# CL148 (PLCA) unresolved CSD related comments

Yong Kim, yong dot kim at nio dot io

V.02

## Compatibility – MII and RS (3) – Conclusion

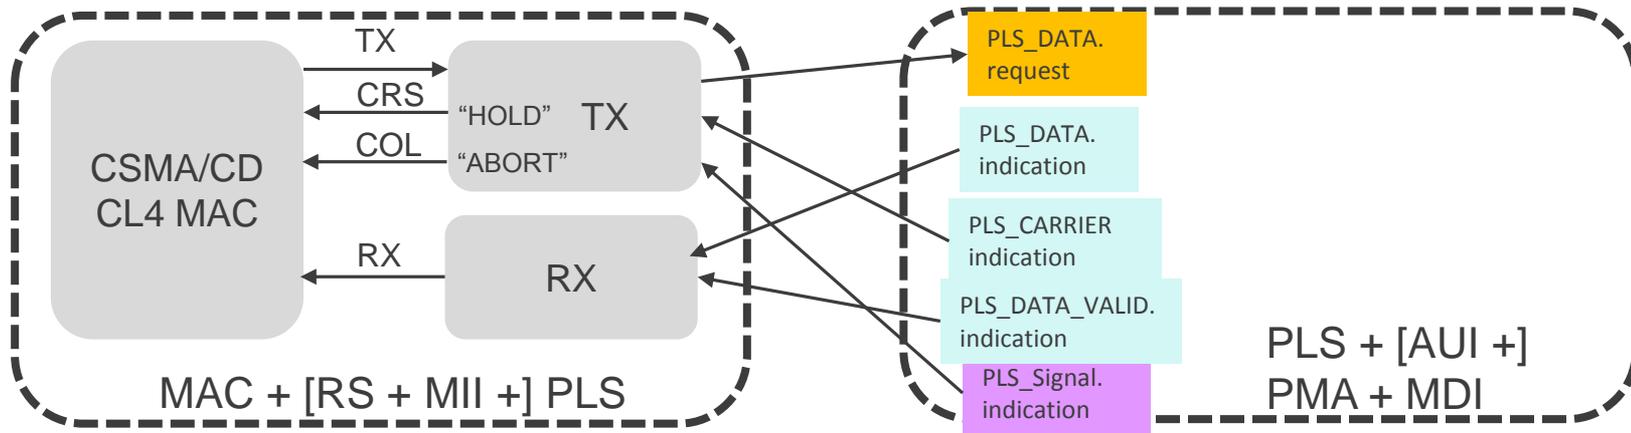
802.3cg draft does not meet the compatibility statement WRT to MII, due to CL148 requiring changes to CL22.

# Compatibility – MAC (2) – PLCA “RS” in CL148

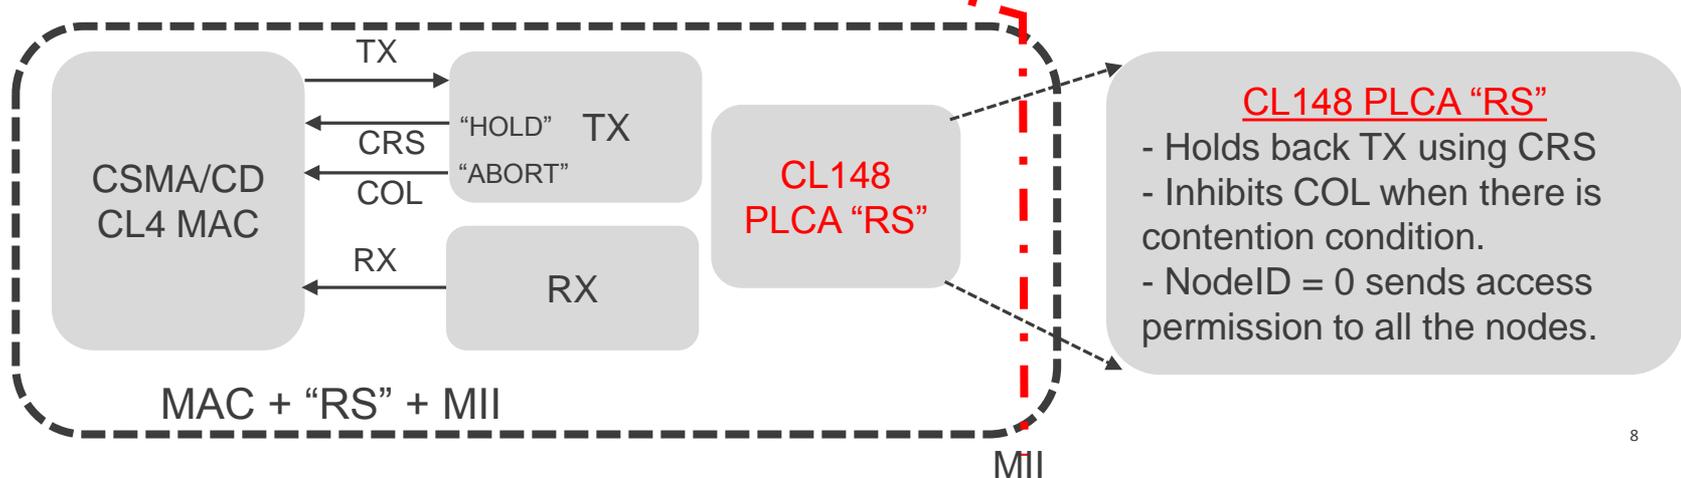
CL148 uses these independent TX and RX datapath definitions in CL4. And then inserts its **own Media Access Control** – that uses Node=0 as the master transmit opportunity sync generator, et cetera.

# Compatibility – MAC (3) – Conclusions and consequences

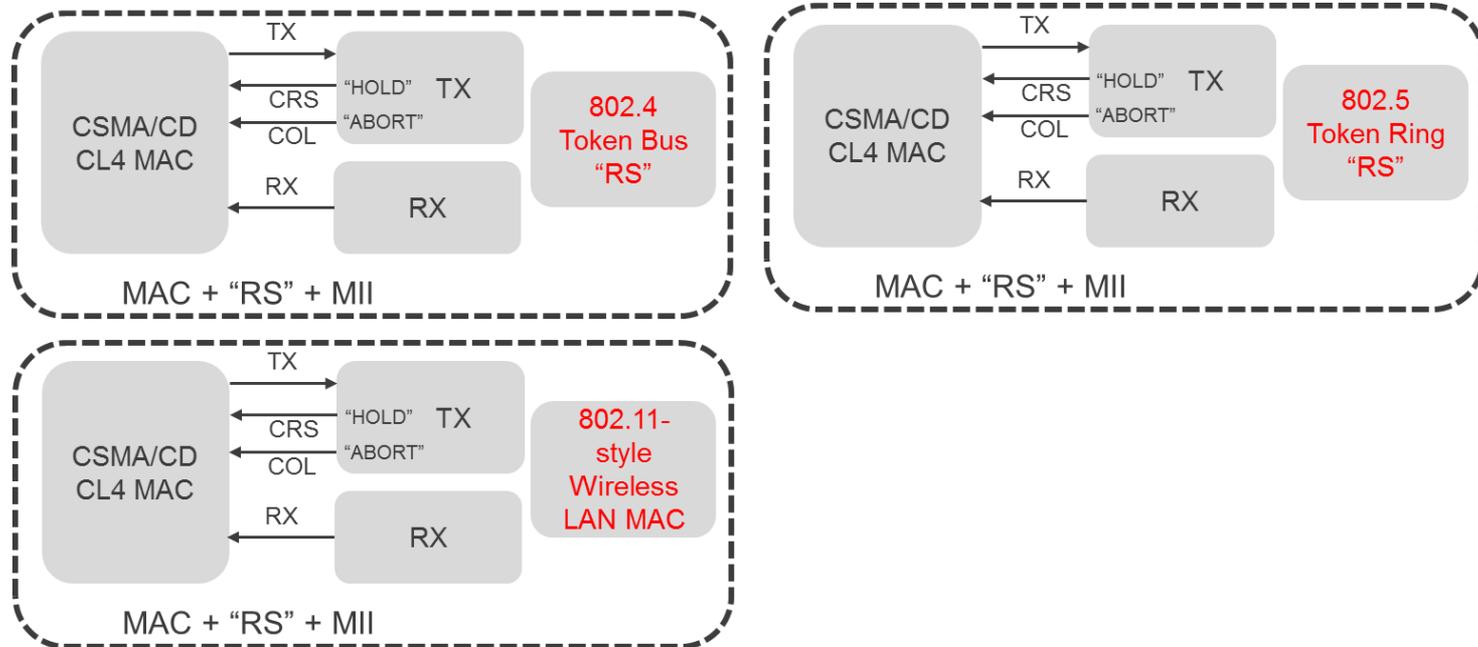
CL148 (PLCA) is a new MAC.

The fact that it interfaces to the CL4 MAC without modification is a distraction to seeing what CL148 is – a new MAC.

But if CL148 is declared to be just an alternate RS Sub-Layer, then I could see some very liberating possibilities and consequences of new class of RS sub-layers (assuming >75% approval) ← being a bit silly here.

## Compatibility – Node ID etc (3) – Conclusions.

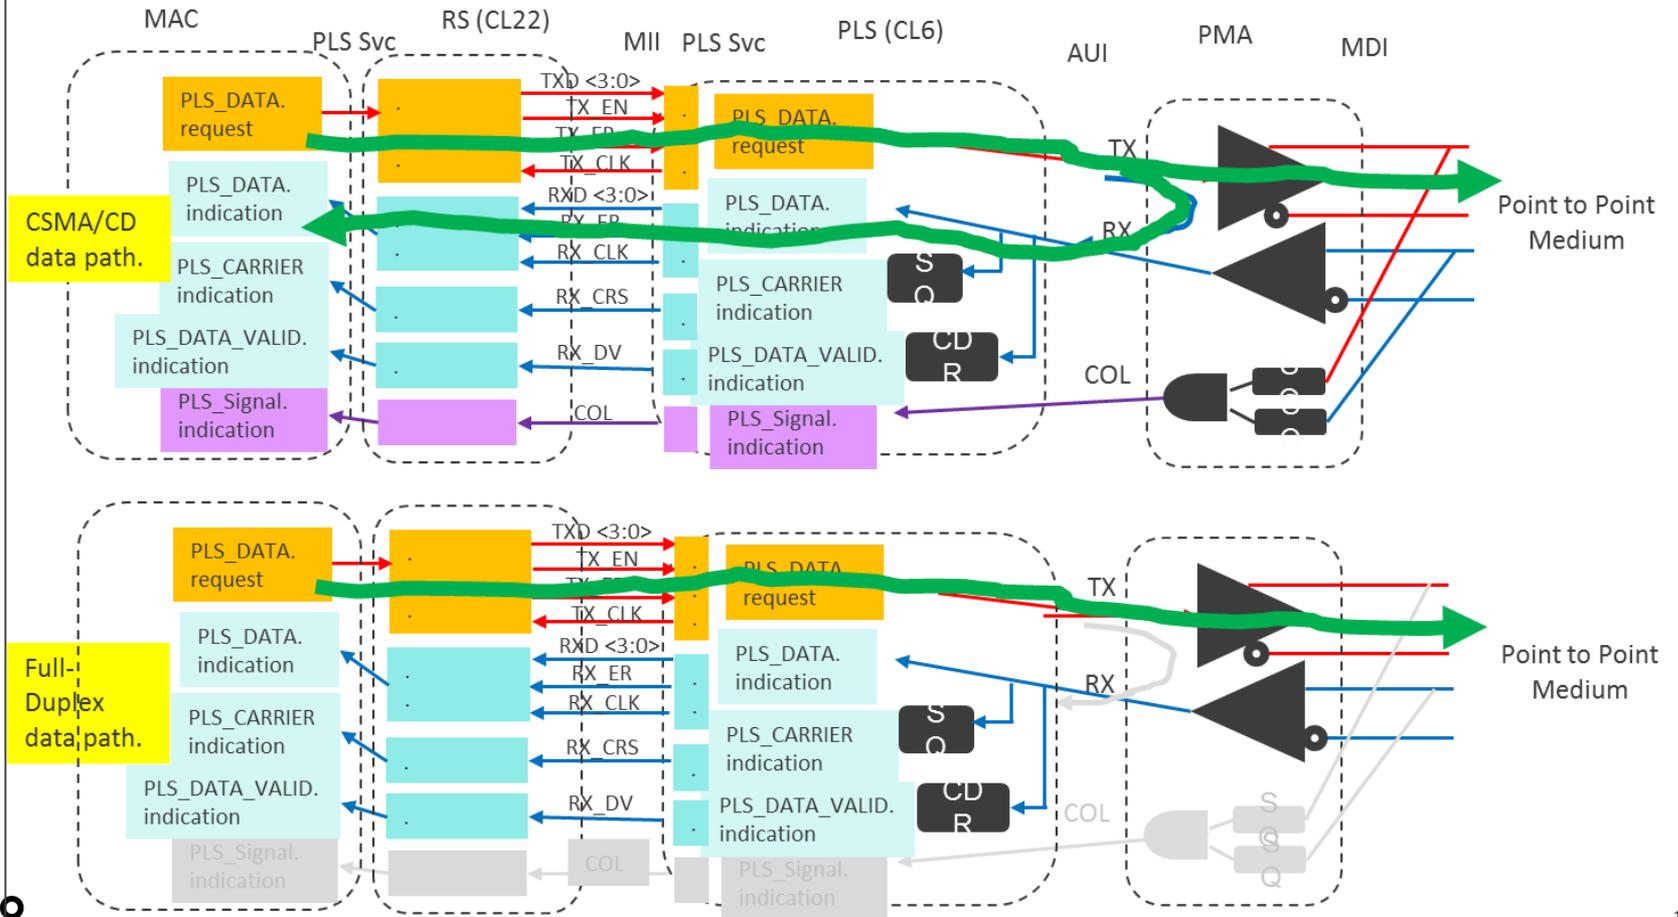
CL148 (PLCA) draft specification is incomplete and no way for two compliant implementations to interconnect and operate.

Due to these incomplete specification, it is not obvious that the stated Economic Feasibility statement of “- The cost factors for Ethernet components and systems are well known” is applied to this standard. All prior Ethernet components are assured to be complete and two or more compliant implementations interconnects and operates without optional management or out-of-band unspecified management actions.
